TEM Server 7.10

Service Release Notes

Revision 7.10.1 • 17-DEC-2021

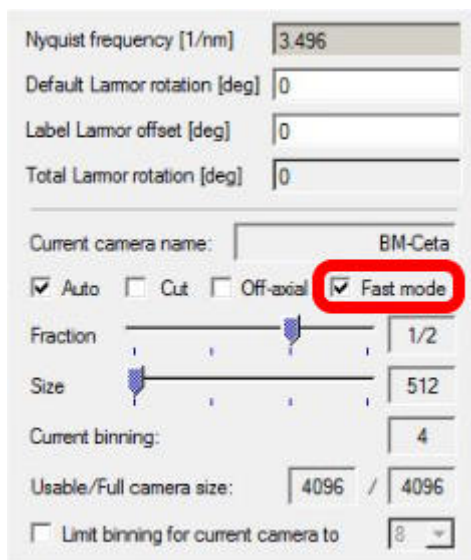
It is now possible to have 4 Automated Aperture Mechanisms (AAMs) on a system without an EDS detector.
